# EcolSciences, Inc.

November 9, 2016

Re: USEPA Comment Letter Response For:  
December 1, 2015 Application for Risk Based PCB Disposal Approval  
450-490 South Avenue and 50 Center Street  
Borough of Garwood  
Block 401, Lots 1 and 2  
Union County, New Jersey  
NJDEP PI# 032470 and 631620

DRAWN BY: DL	DESIGNED BY: DL	APPROVED BY: DL	FIGURE NUMBER: 6
DATE: 11/1/16	SCALE: AS SHOWN	PROJECT NO.: HW14-020

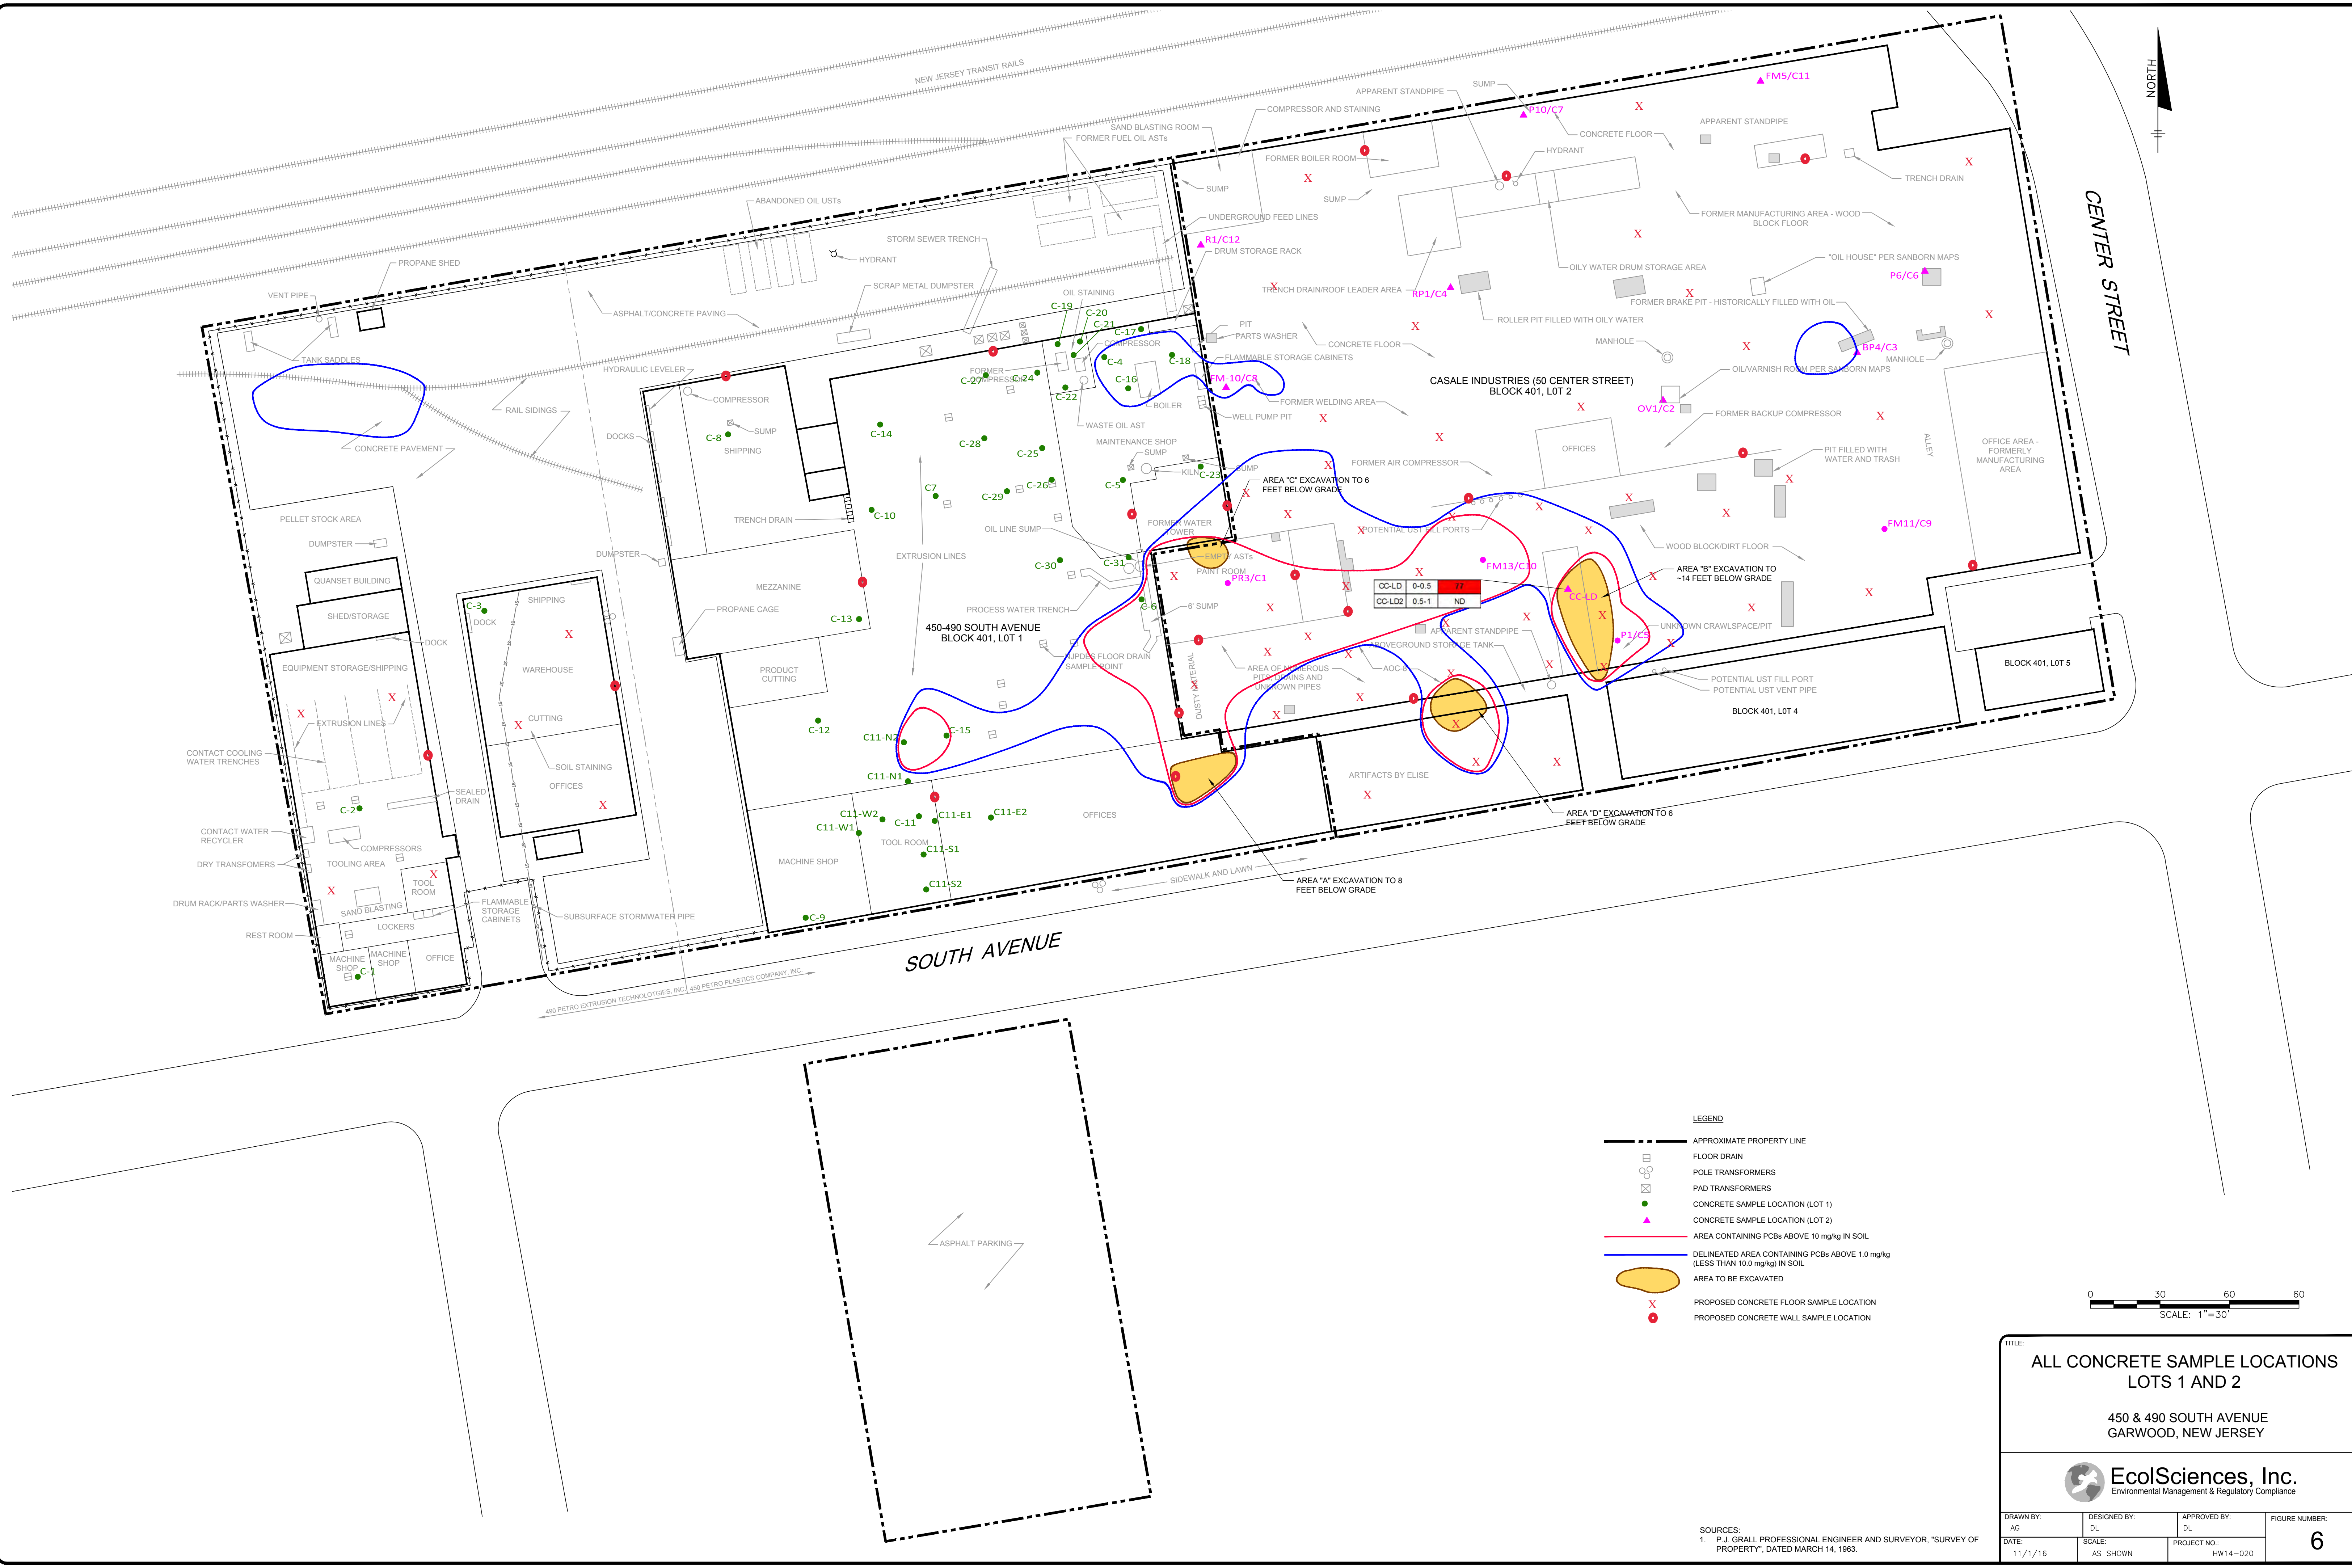
During follow up discussions with Dr. Haklar, the USEPA requested the collection of additional discrete concrete chip samples (number was not specified) and five more composite wood block floor samples (wood block sampling discussed separately, below). Additional concrete chip sampling will be conducted from the concrete floors onsite in an effort to provide analysis to meet an approximate sample frequency of one sample per 1,500 square feet of concrete floor. In the main building on Lot 1, this frequency has already been achieved since thirty-six samples have been collected from the approximately 50,000-square foot area. From the western-most building on Lot 1 (9,000-square feet), four additional concrete chip samples will be collected and from the central building on Lot 1 (6,000-square feet), three additional concrete chip samples will be collected. Regarding the building on Lot 2 which is approximately 90,000 square feet, 60 concrete samples are required to meet the frequency of one PCB sample per 1,500-square feet and 13 surficial concrete samples have already been collected and analyzed for PCBs.

In total, 74 additional concrete samples will be collected and analyzed for PCBs with samples biased towards areas of staining and known PCB impacts in the soil. After completion of the additional sampling, a total of 127 PCB samples will have been collected from the concrete. All of the concrete chip samples will be analyzed for PCBs in accordance with the methodologies specified in the Application. A map depicting the proposed additional concrete sampling locations is included on Figure 6.
